Safety Defect and Noncompliance Report Guide for Vehicles
PART 573 Defect and Noncompliance Responsibility and Reports¹

On September 29, 2009, Coach & Equipment Manufacturing Corp. [MFR] decided that a defect which relates to motor vehicle safety exists in the motor vehicles listed below, and is furnishing notification to the National Highway Traffic Safety Administration in accordance with 49 CFR Part 573 Defect and Noncompliance Responsibility and Reports.

SERVICE BULLETIN

EC Series Electrical System Mandatory Product Improvement

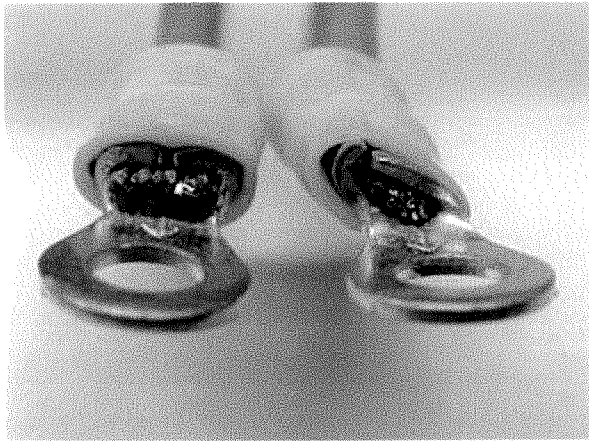
3. All screws on the terminal strip should be replaced with the Torx type screw, supplied in the product improvement kits for EC2.0, EC2.5 & EC3.0, and ***MUST BE*** torqued to 18 in/lbs. (a torque screwdriver is available on a loan basis, from Trans/Air) (Fig 3)

Fig 1

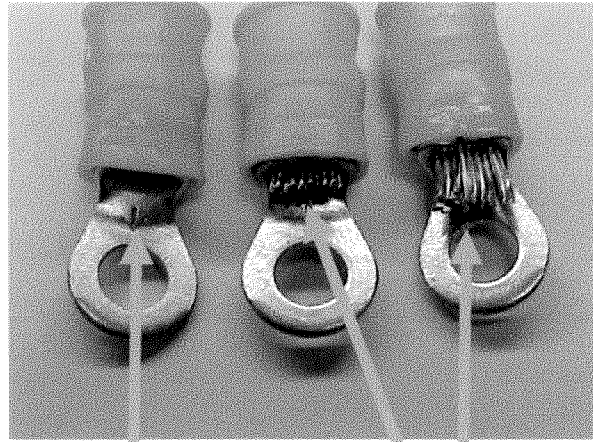
1. Crimps on the wires going to the terminal strip of the relay board should be uniform and tight. There should be no bare wire visible between the wire insulation and the terminal, and strands flush with terminal barrel. (Fig 1 & Fig 2)

Poor Position In Crimper

Poor Wire strands Too long

Correct

Fig 2

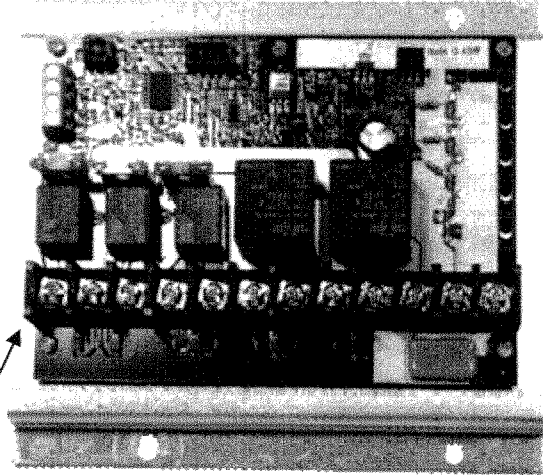
Poor Crimp
